INDESIT company

Model type:
TLA1

Commercial code:
F034567

Notices

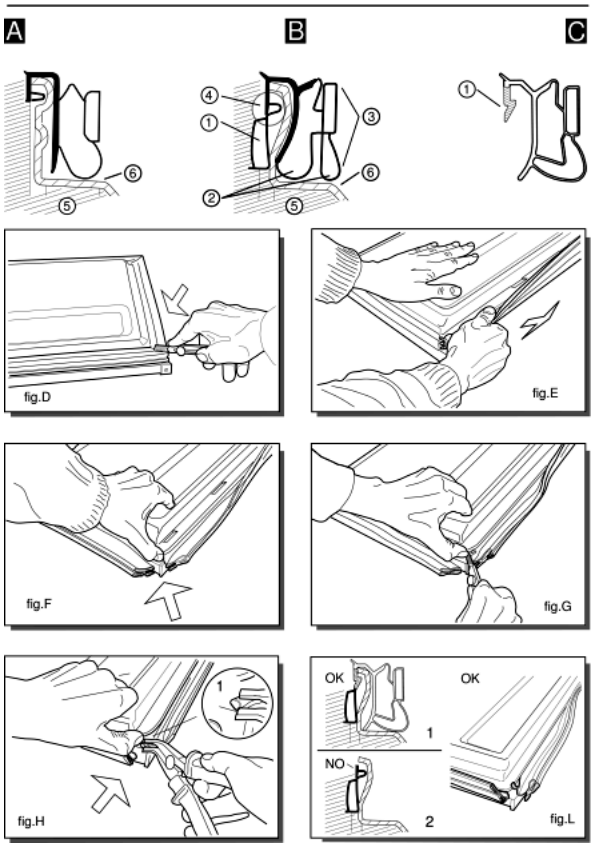
0521123: SEALS FOR DOORS FOAMED AS ONE PIECE

Various types of gaskets with different profile, as shown in figures (A) and (B), are used to fix the door (fig. A-5; B-5) and the inner door (fig. A-6; B-6) on the block foamed doors of combined freezers and refrigerators.
---Ilpea profile 245; 179; 412 (fig.A)
---Ilpea profile 287 (fig.B)
When replacing gaskets with profiles 245; 179; 412 these are fixed with screws (2 per corner) to the door.
Gaskets with profile 287 can not be used as spare parts but are designed to house the Ilpea type 900 gaskets (see figure C).
When replacing the gasket (287), once it is removed you will find a pocket (fig. B-1) between the door and inner door.
The rigid tooth (fig.C-1) of the gasket (900) is inserted inside between the pocket and the inner door, doing away with the need for screws.
Gasket with profile 287 is easy to identify since it has an exterior double edge (fig.B-2) which acts as a cushion when the door is closed.

To replace this gasket, follow these steps:
---Dismount the door and cut the four corners of the gasket along the joint (fig.D);
---lift the gasket and pull it carefully along its full length without tearing it (fig.E).
The purpose here is to detach the inner door slightly from the foam along the exterior edge for a depth equal to that of the gasket (fig.B-3);
---lift the corner of the inner door slightly, prising it up with your thumb (fig.F). Do not use a tool which might break the inner door;
---continue cutting the gasket inside the inner door for about 6 mm (fig.G);
---push in the tip of the pliers (type USAG N131) and pull outwards until you see the top edge of the pocket (fig. B-4) which is empty (fig.H-1);
---if you carry out this operation correctly (fig.L) you will be able to pull off the top edge of the pocket for the full length of the door.
If the gasket tears before the top edge (fig. L-2) you should repeat this operation from the other corner of the door.

---once the gasket (287), has been removed the space above the pocket (fig. L-1) can house the rigid tooth (fig. C-1) of the gasket 900.
When you fit this gasket ensure that it lies flush against the edge for the full length of the door.
If the rigid tooth is difficult to fit, eliminate any residues of foam between the door and the inner door in the gasket area.
fig.5131549A
